Access Compliance Report

Public Rights-of-Way

(Curb Ramps)

Intersection ID: 49297	Main Street: CAMPBELL_HALL_CT	Cross Street: CHAMBERLIN_RD	Location: NW
ADA ID: 5144DAC2E672	Ramp Type: Perp	Initial Pass/Fail: Fail	Overall Compliance: No
Severity Score: 13.75			
Codes/Mitigation Info/Possible Solution		Field Measurements/Component Compliance

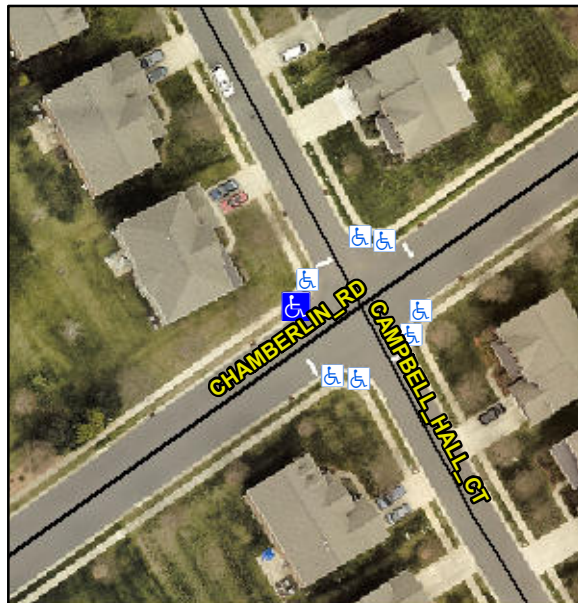
Not Found, R304.2.2, R304.5.3

Compliance	Description	Data	Compliance	Description	Data
N/A	Ramp Length (in)	46.0	No	Ramp Slope (%)	9.6
Yes	Ramp Width (in)	48.0	No	Ramp XSlope (%)	2.4
N/A	Flare Type LT	N/A	N/A	Flare Type RT	N/A
N/A	Flare Slope LT (%)	N/A	N/A	Flare Slope RT (%)	N/A
N/A	Flare Traversable LT?	N/A	N/A	Flare Traversable RT?	N/A
N/A	Landing Length (in)	N/A	N/A	DWS Provided?	N/A
N/A	Landing Width (in)	N/A	N/A	DWS Contrast?	N/A
N/A	Landing Slope (%)	N/A	N/A	DWS Length (in)	N/A
N/A	Landing X Slope (%)	N/A	N/A	DWS Full Width?	N/A
N/A	Landing Curb? (Y/N)	N/A	N/A	DWS Offset (in)	N/A
N/A	Shared Landing?	N/A			
N/A	Gutter Ponding?	N/A	N/A	Gutter Slope (%)	N/A
N/A	Gutter Lip Ht (in)	N/A	N/A	Gutter X Slope (%)	N/A
N/A	Painted X Walk1?	No	N/A	Painted X Walk2?	N/A
	X Walk 1 Direction	To SW		X Walk 2 Direction	N/A
N/A	X Walk 1 Width (in)	N/A	N/A	X Walk 2 Width (in)	N/A
	X Walk 1 Slope (%)	5.7		X Walk 2 Slope (%)	N/A
	X Walk 1 X Slope (%)	0.9		X Walk 2 X Slope (%)	N/A

Remove & Replace Entire Ramp.
